FIELD SERVICE BULLETIN NO. 5

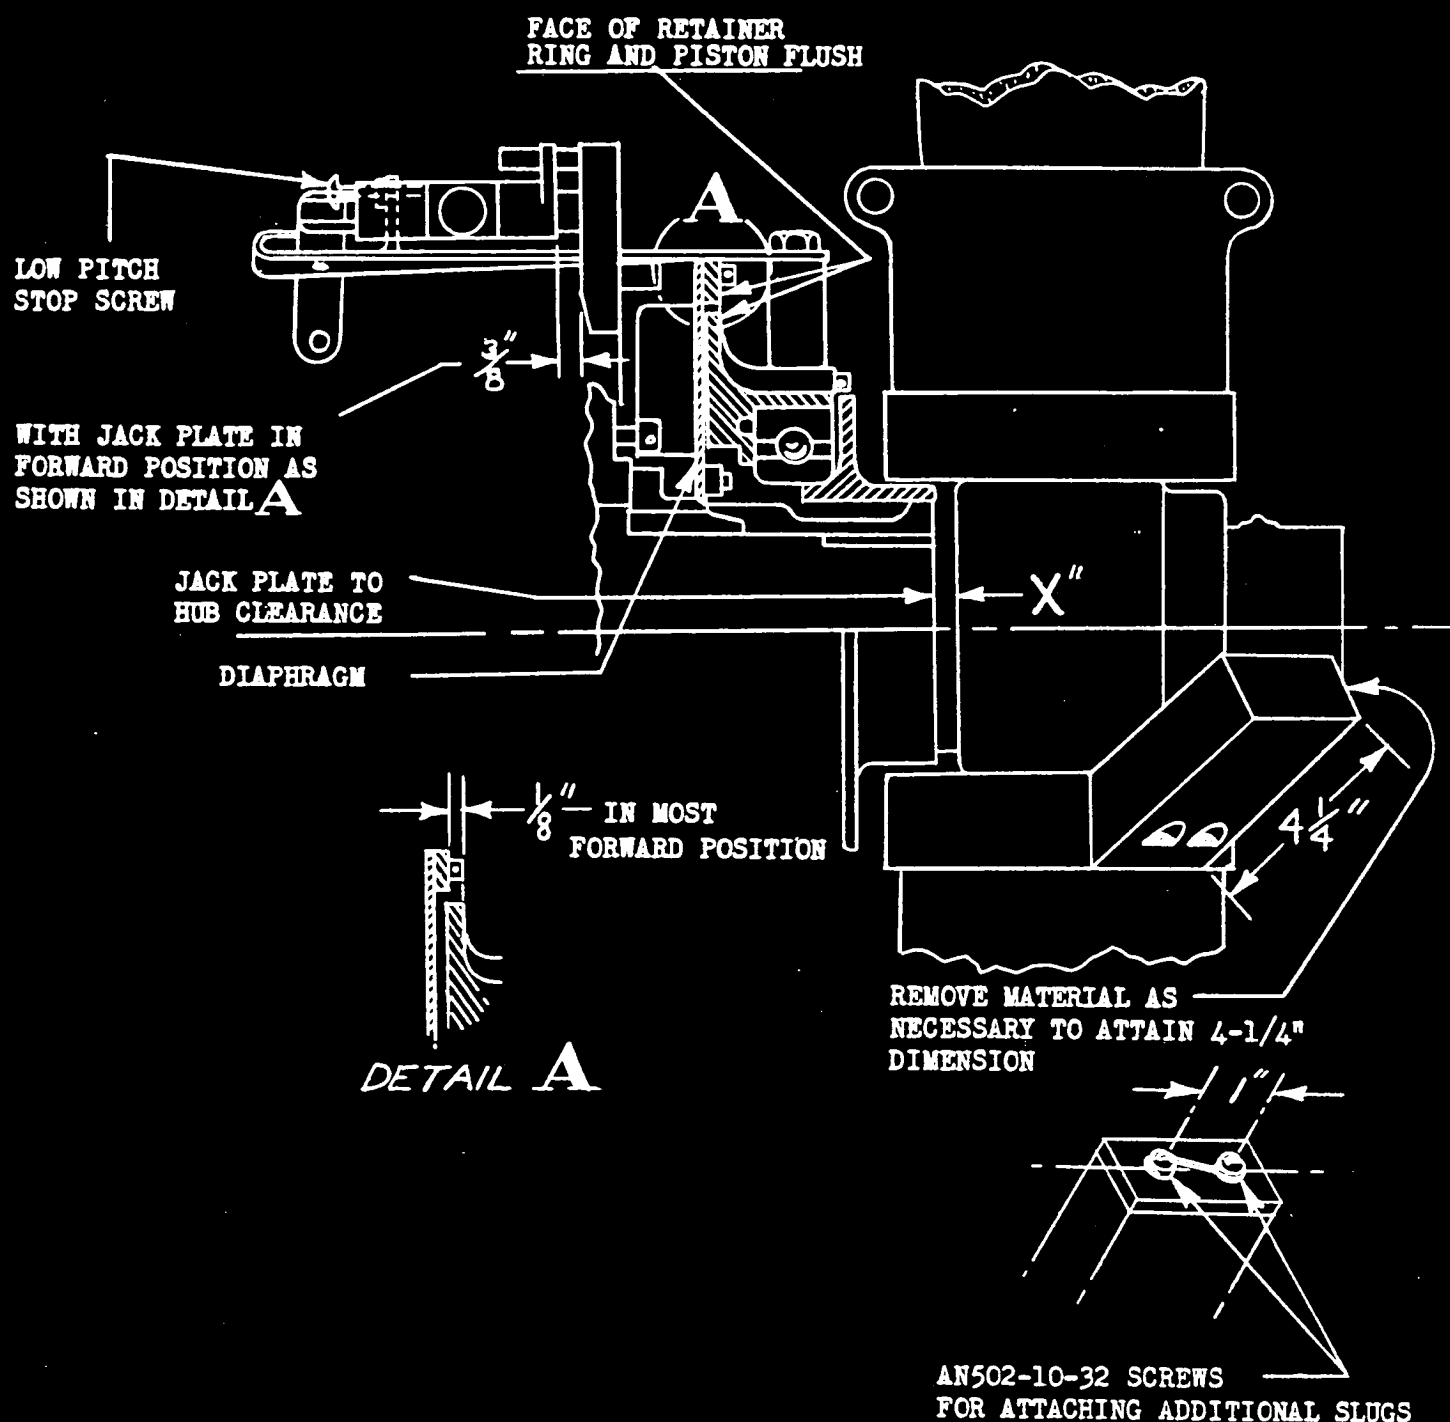
WITH FACE OF PISTON AND RETAINER RING FLUSH
Dimension X = 1/4" on -7, -7A or -7B Propellers

WITH PISTON IN FULL FORWARD POSITION (SEE DETAIL "A")
Dimension X = 1/8" on -7, -7A, or -7B Propellers

NOTE: WITH HYDRAULIC ELEMENT PISTON IN FULL FORWARD POSITION DIMENSION "X" SHOULD BE 1/16" MINIMUM ON -1 or -5 HARTZELL PROPELLERS
